OFFICE OF RATEPAYER ADVOCATES
CALIFORNIA PUBLIC UTILITIES COMMISSION

**The Office of Ratepayer Advocates’
Report on
Pacific Gas and Electric Company’s
Cost of Service and Rates for Gas
Transmission and Storage
Services for the Period 2019 - 2021**

Depreciation & Decommissioning

San Francisco, California
June 29, 2018

Figure 14B-1
Account 353: Lines
Placement band 1936-2014 • Experience band 1981-2016
Test Year 2019

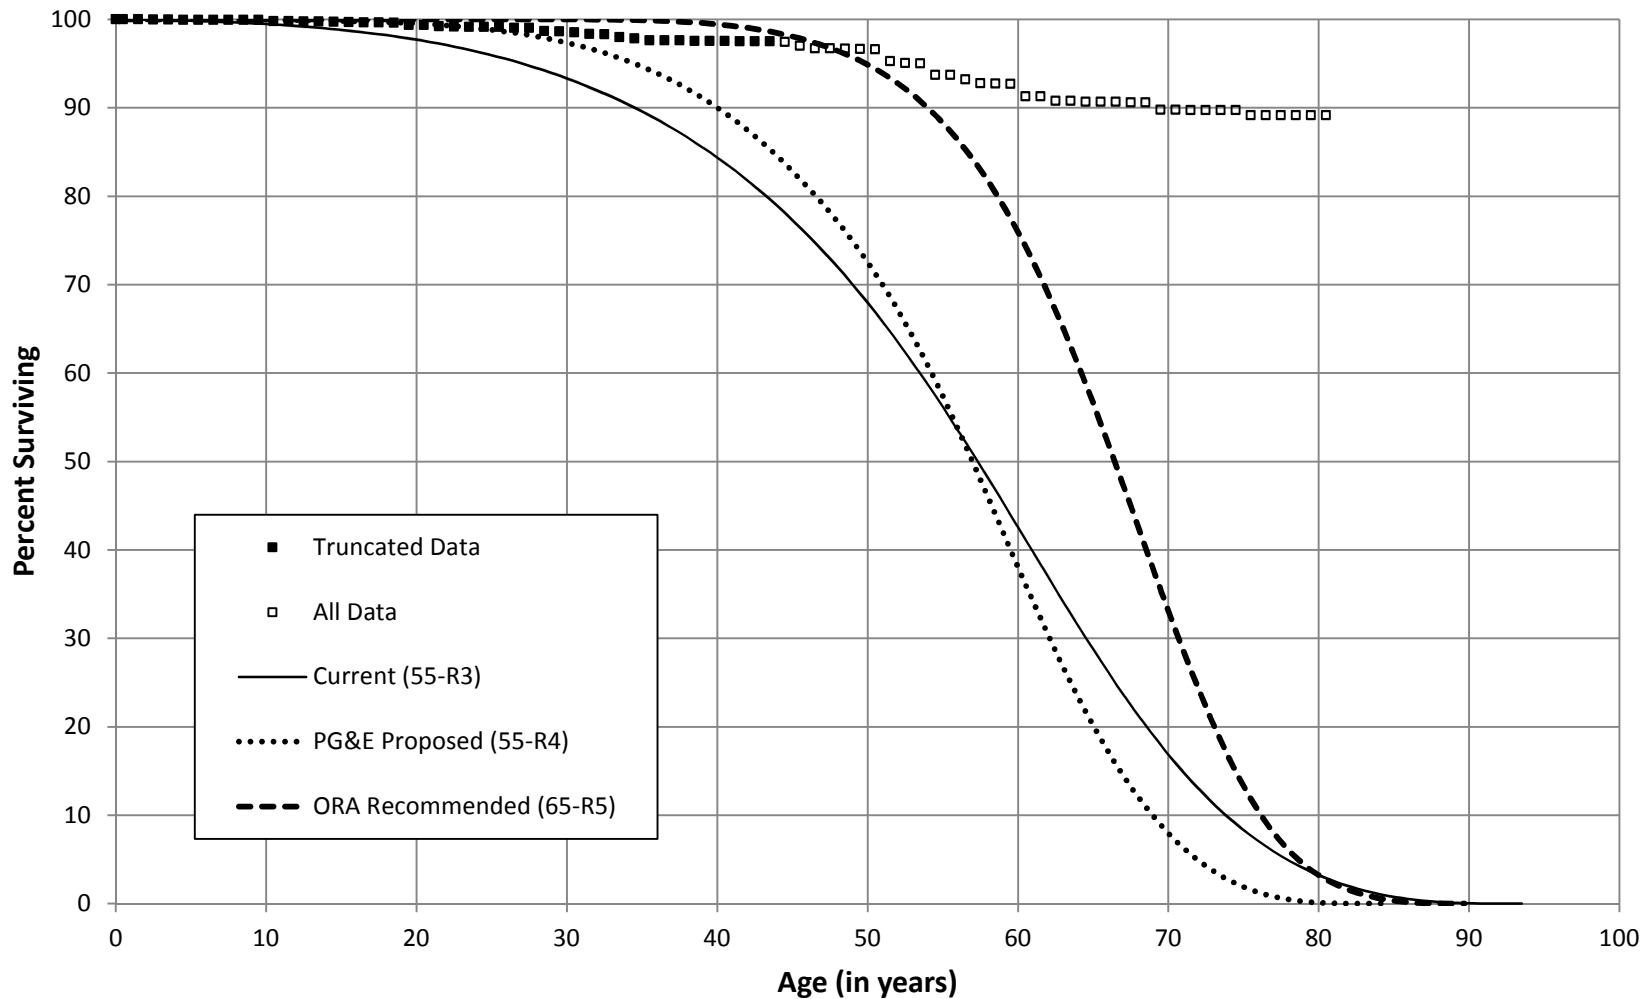
10 ORA recommends the Commission adopt the 65-R5 curve for Account 353.
11 The stub curve, which displays PG&E’s historical data, is not a strong match for
12 either the 55-R3 curve or the 55-R4 curve, as shown on the following page. PG&E
13 bases its recommendation in part upon the truncation of its historical data to age
14 43.5.¹² In its previous GT&S case, PG&E truncated its historical data to age 63.5.¹³
15 The data itself did not change significantly between the two cases. PG&E’s decision
16 in the instant GT&S proceeding to truncate its historical data to age 43.5 is
17 inappropriate. The consequence of this truncation is to portray the 55-R4 curve as a
18 more reasonable match for the actual data than a curve with a longer average
19 service life. This is because the truncation of the stub curve reduces the gap in
20 area, or realized life, between the stub curve and the 55-R4 curve. The large gap in

21 area between the 55-R4 curve and the entire stub curve evinces the poor fit of the
22 55-R4 curve. The same large gap also persists if the 55-R4 curve is compared to
23 the stub curve truncated at age 67.5, which would match the amount of data
24 considered in the previous GT&S proceeding. This illustrated in Figure 14B-1.

10 ORA’s recommendation of the 65-R5 curve more accurately represents the
11 depreciation of this account. This curve captures the few retirements of plant in its
12 first decades of life, and it maintains the reasonable end of life characteristics of the
13 existing 55-R3 curve. Overall, the curve captures the retirement of approximately 90
14 percent of plant between ages 50 and 80. ORA’s recommended 65-R5 curve also
15 addresses PG&E’s observation that “[s]torage lines are more subject to corrosion
16 than transmission mains, since well gas is not as dry as pipeline gas,”¹⁶ because the
17 R5 curve shifts the realization of life to younger ages, as compared to the R2 curve
18 of Account 367 (Mains). For a given age of plant, the steepness of the R5 curve
19 produces a higher realized life than the R2 curve of Account 367 (Mains).

Figure 14B-2
Account 356: Purification Equipment
Placement band 1949-2016 • Experience band 1981-2016
Test Year 2019

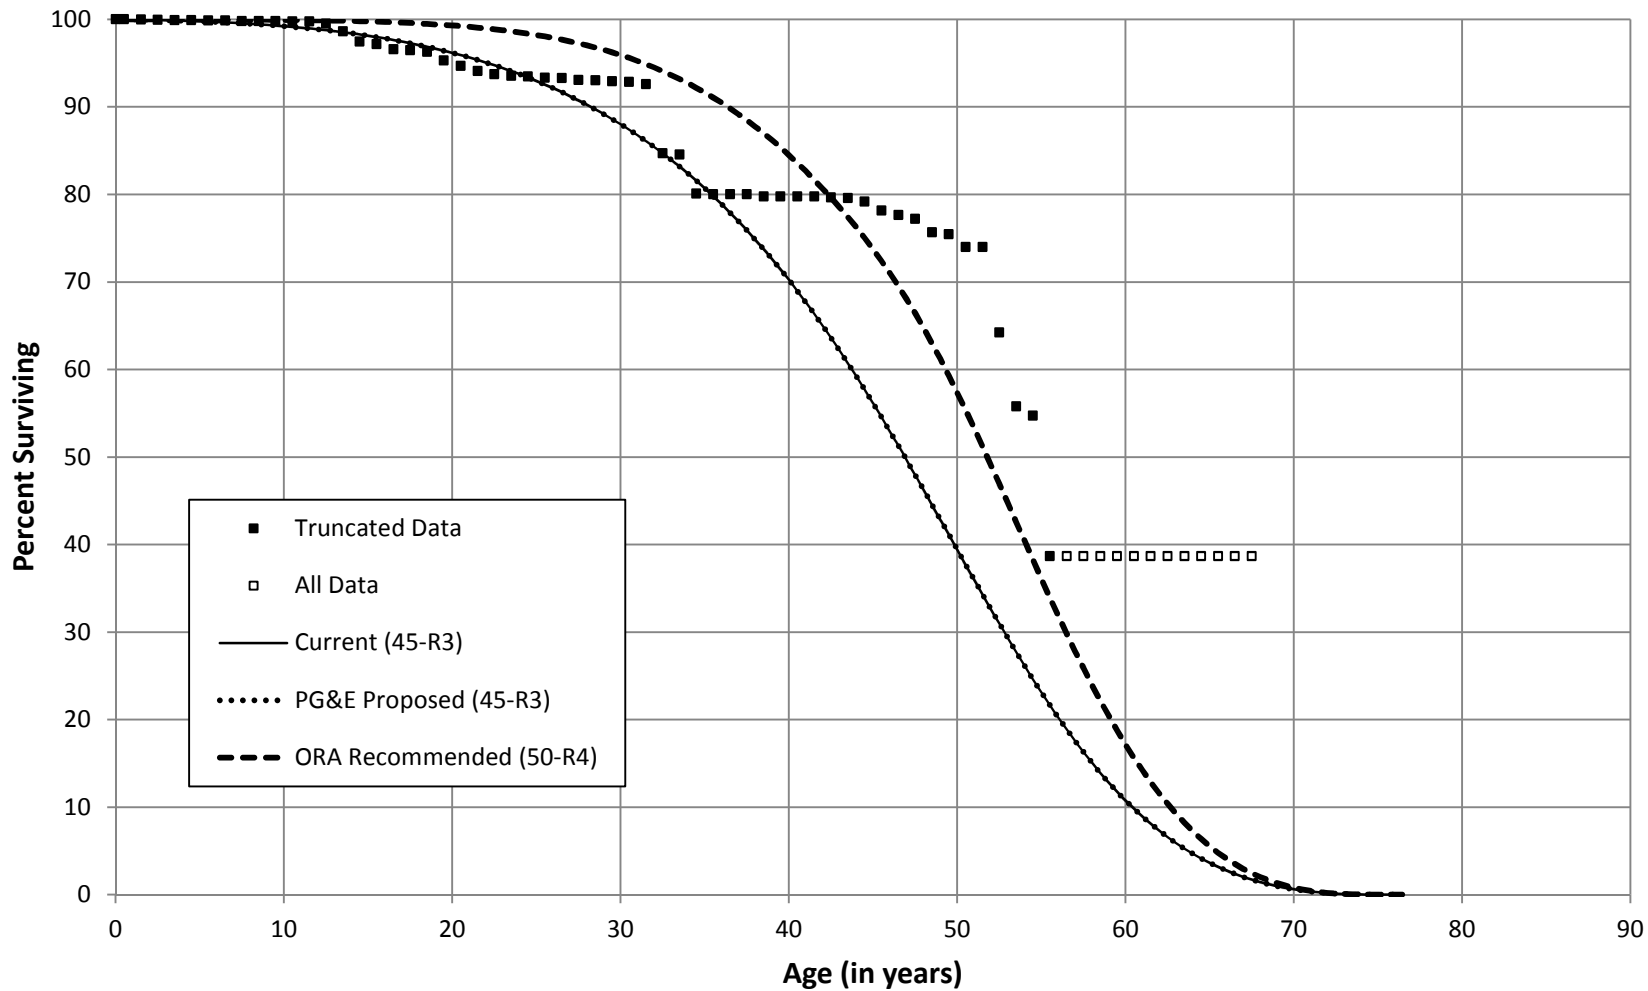
ORA recommends the Commission adopt the 50-R4 curve for Account 356. The 45-R3 curve matches the first 25 years of the stub curve well, but it is not a strong match for the remainder of the curve, as shown on the following page. For example, the 45-R3 curve assumes that only 40% of plant will remain in service by age 50. The stub curve shows that approximately 75% of plant has historically survived to age 50.

PG&E truncates the stub curve to age 55.5. Because assets at higher ages are denominated in dollars from many decades ago, a seemingly small nominal dollar amount may correspond to a significant amount of real property. So long as this plant remains in service, it contributes to the overall characteristics of the account and offers evidence of retirement activity patterns in old age. ORA does not discount this property entirely, as occurs when the stub curve is truncated. The fact that older plant evinces limited retirement activity is useful information, which adds to the evidence in favor of a longer service life.

ORA's recommendation of the 50-R4 curve more accurately represents the depreciation of this account. Approximately 90 percent of plant retires between ages 30 and 65. The end-of-life characteristics remain substantially similar to the 45-R3 curve. Overall, ORA's recommendation is a conservative estimate, since ORA uses the experience band of 1981-2016, rather than the more recent experience band of 1999-2016. If the experience band was limited to 1999-2016, the stub curve would suggest an even longer service life and evince an even larger gap between the stub curve and PG&E's proposed 45-R3 curve.

Figure 14B-3
Account 369: Measuring and Reg. Station Eq.
Placement band 1926-2016 • Experience band 1981-2016
Test Year 2019

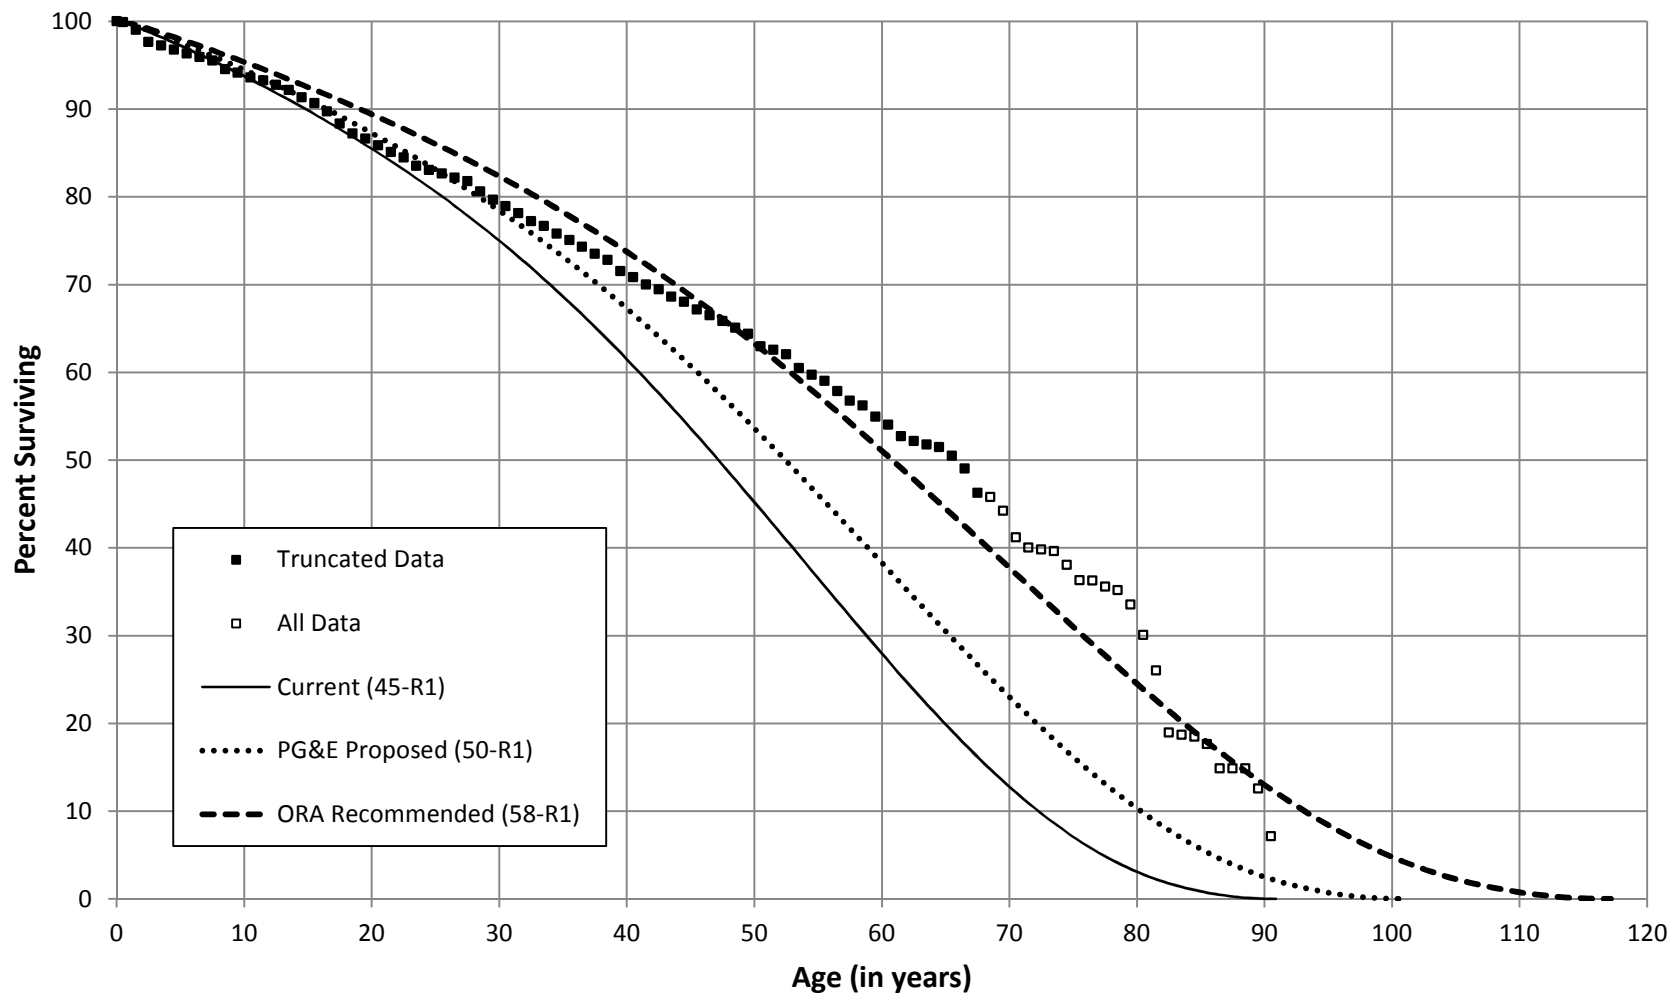
8 ORA recommends the Commission adopt 58-R1 for Account 369. The
9 proposed 50-R1 curve understates the percent surviving at most ages above 40, as
10 shown on the following page. PG&E argues that it “expects that the level of
11 replacements of assets at stations may increase going forward, as testing of stations
12 could lead to increased replacement activity.”²¹ The expectation of increased
13 retirement activity is insufficient justification for the adoption of a service life that is
14 shorter than otherwise suggested by the data. The prospect that hypothetical
15 retirements may eventually appear in the data is speculative. For further discussion,
16 please see the discussion of Account 353 (Lines). The Commission should not
17 adopt inappropriately short average service lives on the basis of hypothetical activity
18 that has not yet appeared in the data. If retirement activity does in fact increase, the

19 data should appear in PG&E’s next depreciation study, and any necessary
20 adjustments can be considered in the next GT&S proceeding.

Figure 14B-4
Account 371: Other Equipment
Placement band 1931-2016 • Experience band 1981-2016
Test Year 2019

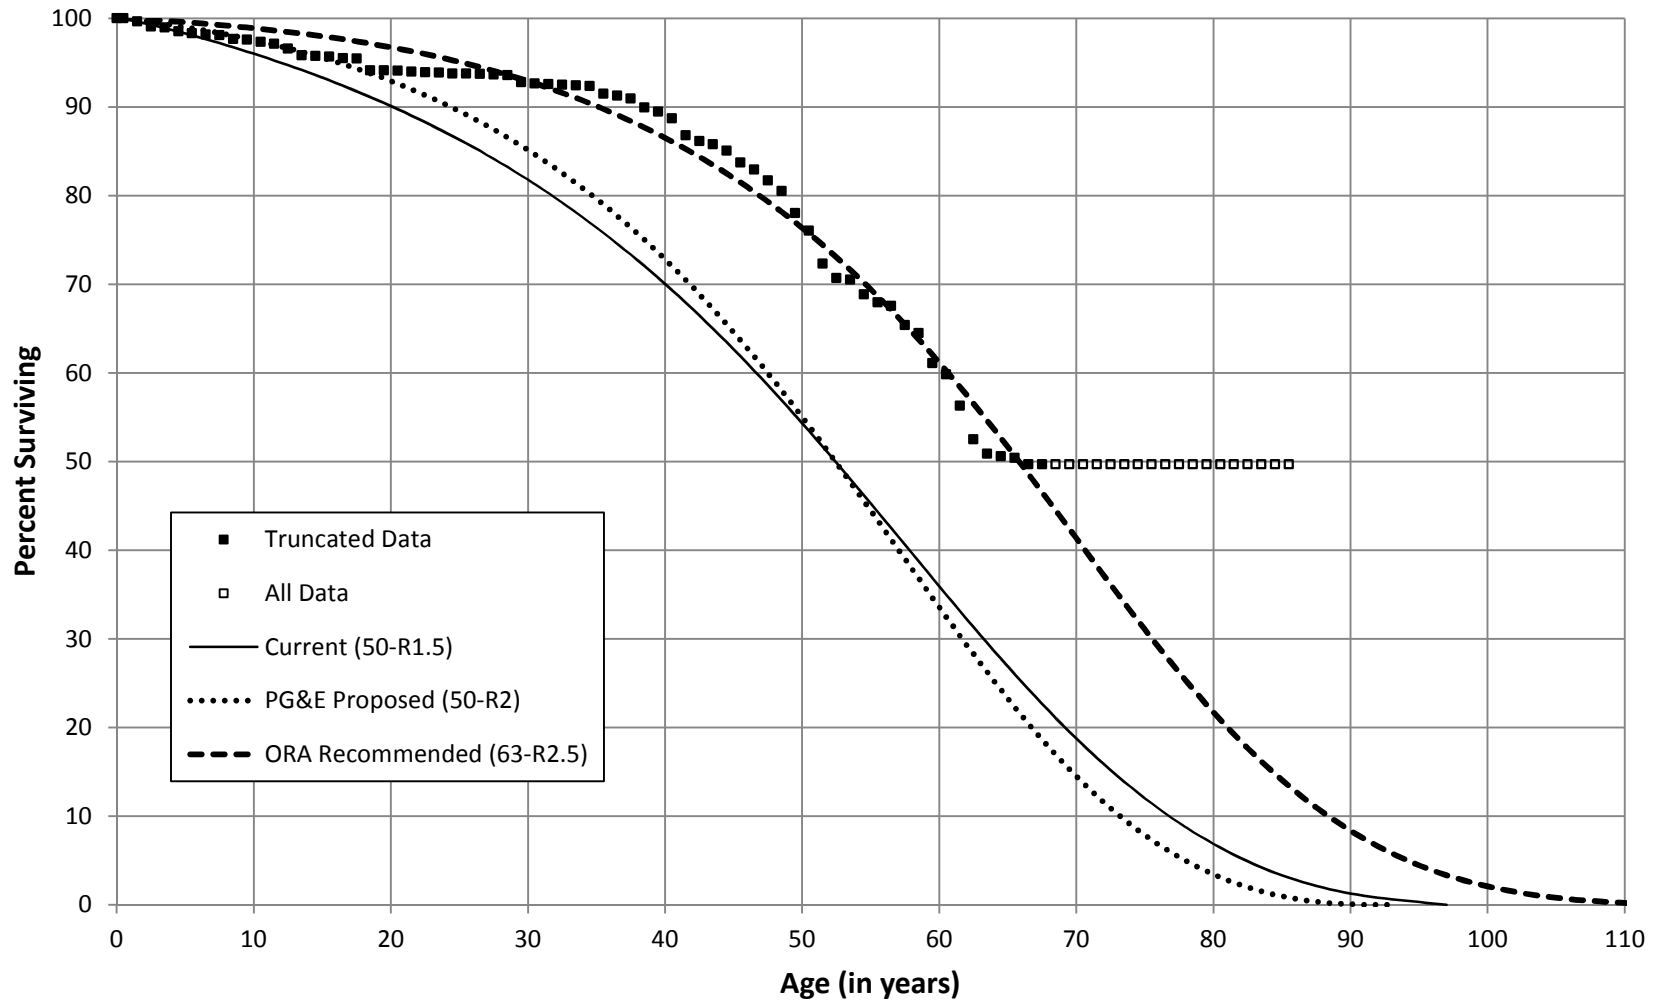
8 ORA recommends the Commission adopt the 63-R2.5 curve for Account 371.
9 PG&E calculates that this is the best fit curve for the stub curve data points.²⁴ The
10 63-R2.5 curve is an excellent fit through age 67.5, as shown on the following page.
11 There is limited retirement activity beyond this age, which provides additional
12 evidence for a longer average service life than 50 years. For most stub curve data
13 points above age 20, PG&E's proposed 50-R2 curve significantly underestimates the
14 actual percent surviving at that age.

15 PG&E cites the inclusion of new assets as reason to avoid increasing the
16 average service life.²⁵ ORA recommends the use of the recorded data as the basis
17 of its adjustments for this account. If the changing asset mix truly alters the overall
18 account characteristics, additional adjustments can be considered in a future GT&S
19 proceeding, when a new depreciation study has clarified the nature of the changing
20 parameter(s). Until then, the best-fit 63-R2.5 curve is an appropriate representation
21 of the evident life characteristics of Account 371.

Figure 14B-5
Account 367 (Mains) – Net Salvage Activity
(\$ millions)

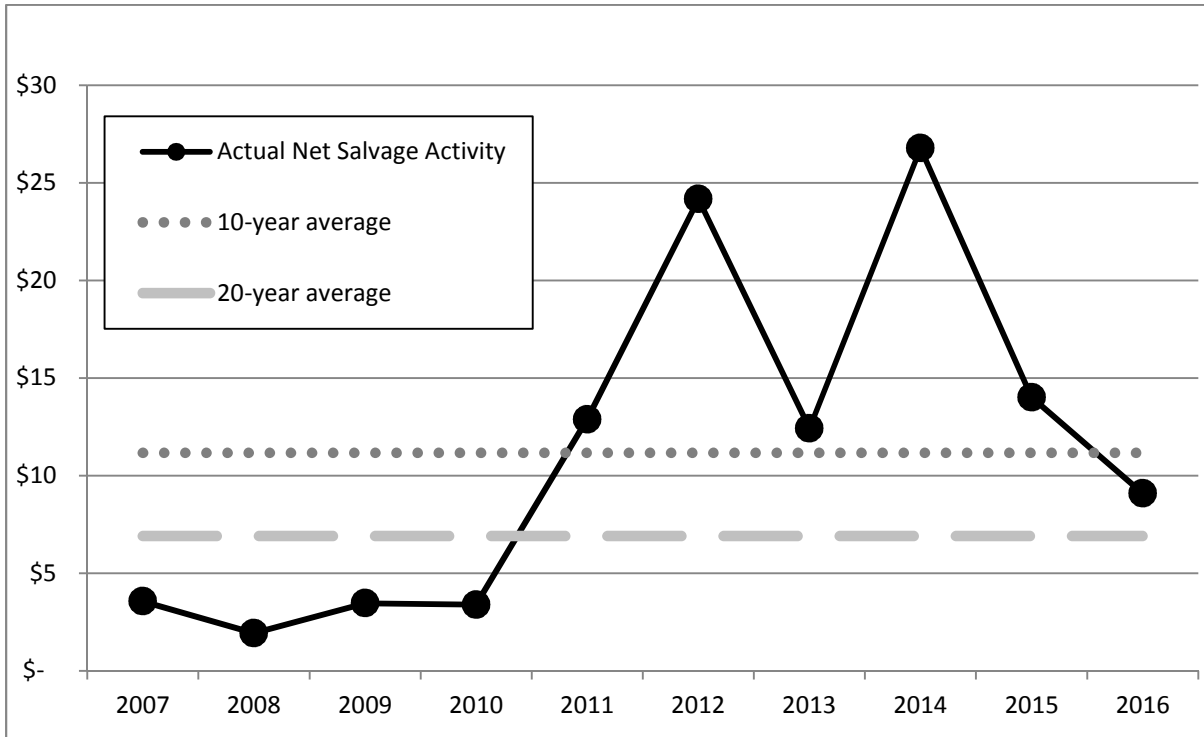
10 ORA recommends negative 44% for the net salvage rate of Account 367.
11 PG&E’s proposal is the highest (i.e., most negative) net salvage rate recommended
12 by its depreciation consultant, Gannett Fleming, in comparison with the net salvage
13 rates for Account 367 (Mains) estimated by Gannett Fleming in other utilities’ rate
14 cases.³⁴ Across those utilities, the median net salvage rate for mains estimated by
15 Gannett Fleming is negative 20%. The modal (most common) value is negative
16 10%.

17 ORA’s recommendation ensures that PG&E will continue to collect net
18 salvage amounts that significantly exceed the account’s actual net salvage activity.
19 Figure 14B-5, below, shows the actual net salvage activity of Account 367 for the
20 most recent ten years examined in PG&E’s depreciation study.

1 If the Commission adopts ORA’s recommendation, PG&E will collect the
2 annual sum of \$19.768 million for the future net salvage of its 2016 year-end gross
3 plant, plus amounts for post-2016 capital additions. These collections exceed the
4 ten-year average annual net salvage (i.e., actual net salvage activity) by more than
5 \$8 million, and they are nearly three times as large as the twenty-year average
6 annual net salvage. These collections also exceed the average net salvage of the
7 most recent six years (2011-2016) by approximately \$3 million. These six years
8 evince higher levels of net salvage activity than previous years. PG&E explains that
9 this higher average level may overstate the true net salvage characteristics of the
10 overall account.³⁵
